SUBJECT: TURKEY POINT NUCLEAR GENERATING, UNIT NOS. 3 AND 4 - STAFF
ASSESSMENT OF RESPONSE TO 10 CFR 50.54(f) INFORMATION
REQUEST - FLOOD-CAUSING MECHANISM REEVALUATION (TAC NOS.
MF1114 AND MF1115)

STAFF ASSESSMENT BY THE OFFICE OF NUCLEAR REACTOR REGULATION
RELATED TO FLOODING HAZARD REEVALUATION REPORT
NEAR-TERM TASK FORCE RECOMMENDATION 2.1
RELATED TO THE FUKUSHIMA DAI-ICHI NUCLEAR POWER PLANT ACCIDENT
TURKEY POINT NUCLEAR GENERATING, UNIT NOS. 3 AND 4
DOCKET NOS. 50-250 AND 50-251

Figure 3.2-1 Example of FLO-2D results, showing maximum water depths predicted in modeling of LIP Scenario A over the entire model domain. (Source: FHRR Figure 4-6)

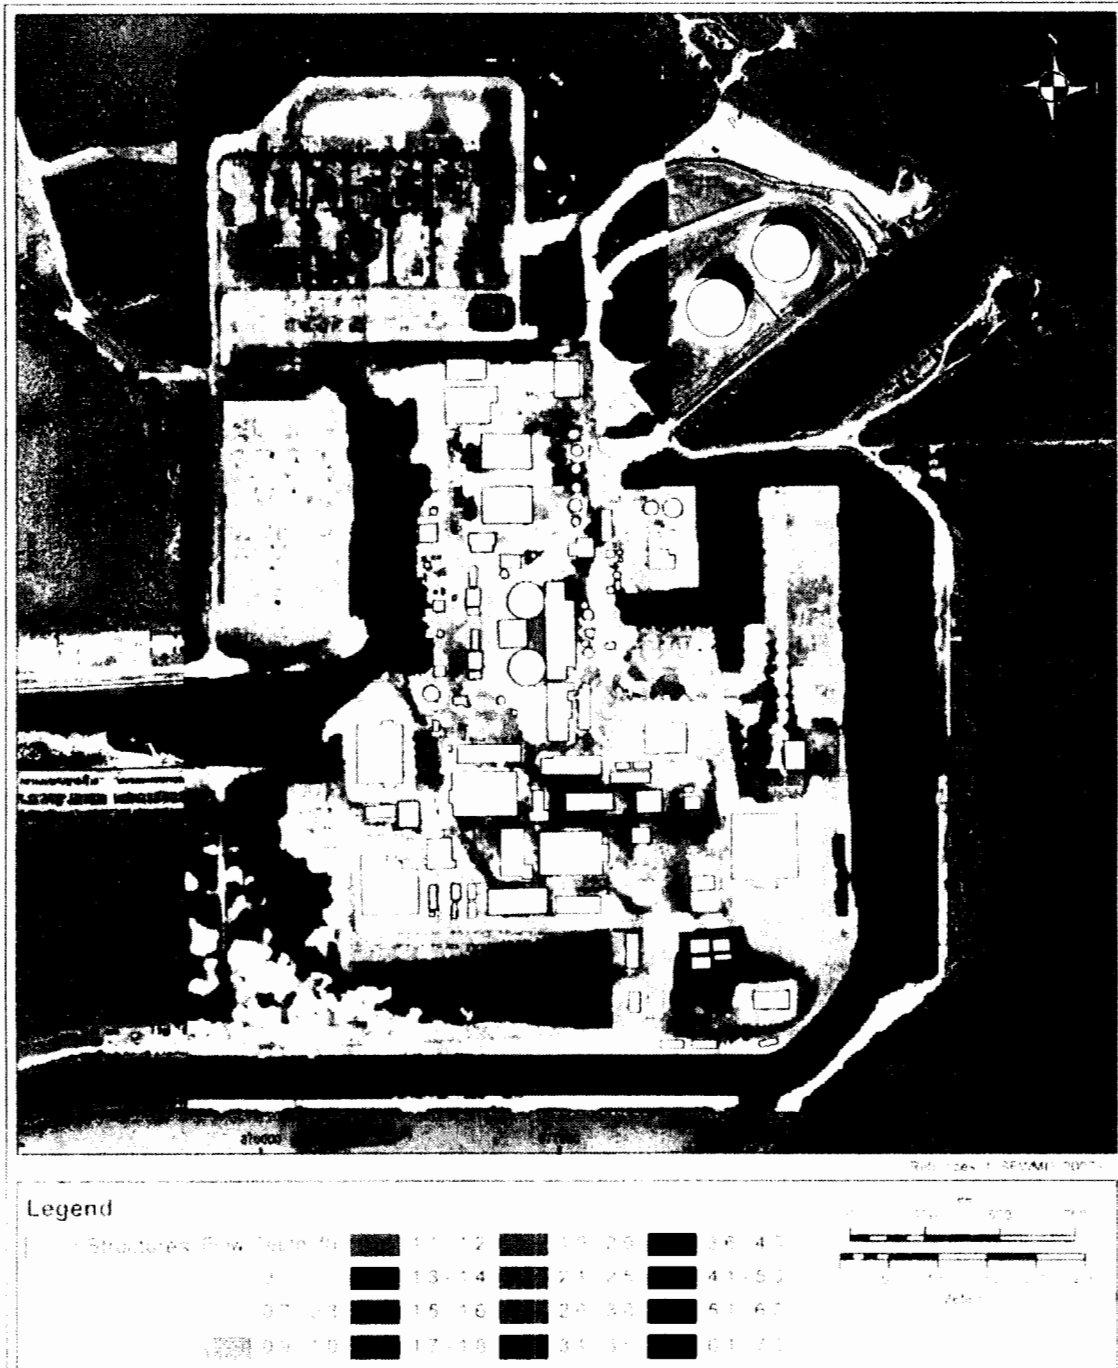
The licensee used FLO-2D to simulate the generation and flow of runoff from the one-hour PMP event, represented by applying the rainfall over the model grid at one-minute increments, as indicated in Table 3.2-2. Figures 3.2-1 and 3.2-2 illustrate the results of one model run for Scenario A. Figure 3.2-2 shows the locations of POIs. The licensee did not provide similar figures for Scenario B in its FHRR.
